*City of Alexandria, Virginia*

MEMORANDUM

DATE: OCTOBER 29, 2003  
TO: CHAIRMAN AND MEMBERS OF THE PLANNING COMMISSION  
FROM: EILEEN P. FOGARTY, DIRECTOR, PLANNING AND ZONING   
SUBJECT: DSUP #2002-0048; MPA #2003-0004; REZ #2002-0005  
QUAKER RIDGE, 3517-3551 DUKE STREET

Docket Item #11-A and 11-B  
MASTER PLAN AMENDMENT #2003-0004 (11-A)  
REZONING #2002-0005 (11-B)  
QUAKER RIDGE

Staff Proposal

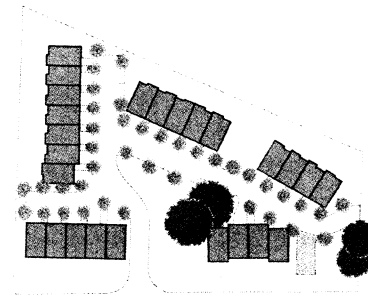
At the request of staff, the applicant has retained several mature trees located in the central portion of the site and in a landscape buffer on the northern and eastern portion of the site, which provide a canopy and coverage for the adjoining residents. However, with eleven units proposed on the northern portion of the site, several of the larger trees would be eliminated. To create a larger landscape buffer and retain groupings of the existing tree canopy adjacent to Quaker Village, staff is recommending the elimination of lots 18, 19 and 24. With the elimination of these units, a grouping of large trees can be retained on lots 18 and 19, which will augment the landscape buffer on the perimeter of the site and maintain the character of the site, while providing considerable visual relief and screening for the adjoining residents. Further, staff is recommending the elimination of lot 24 in order to relocate the internal street and thereby provide a larger buffer along the northern property line adjacent to Quaker Village.

In summary, to maintain the character of the site and provide adequate buffering for adjacent residents, staff is recommending that three of the proposed units be eliminated. While there may be alternative lot arrangements to provide buffering and retain the mature trees, this approach provides an effective retention of trees, open space, and wooded buffer.

Staff Proposed Site Plan

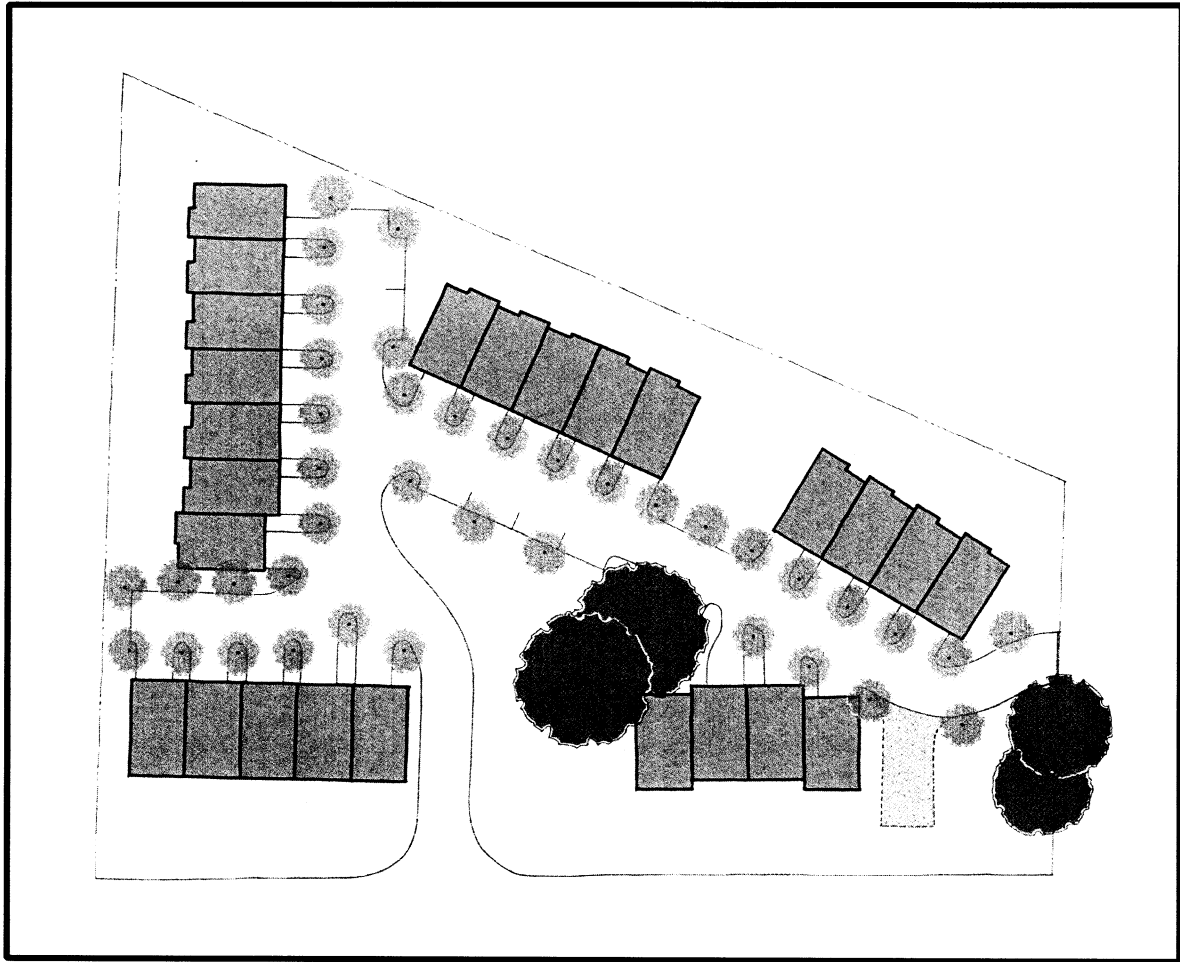
Seeking that balance, staff recommends that the total number of units be limited to 25, or three units less than proposed by the applicant, in order to provide a greater buffer between the proposed development and its neighbors, to preserve large trees, and to provide larger, more visually connected open spaces within the proposed development. Staff has prepared an alternative site layout that eliminates two units located along the northern property line and shifts the units to the south, providing a 10-foot buffer of screening for the adjacent Quaker Village development immediately to the north of the subject property. The shift results in the loss of two units (Lots #18 and #19), but in exchange will protect a grouping of large trees that are currently proposed to be removed by the applicant, and will create another smaller open space area that is visually connected to the larger open space within the development and adjacent to Duke Street. Staff also recommends elimination lot #24 along Duke Street, in order to provide more open space adjacent to Duke Street. The staff proposal will result in the elimination of three units. While there may be alternative lot arrangements to provide buffering and retain the mature trees, this approach provides an effective retention of trees, open space and wooded buffers.
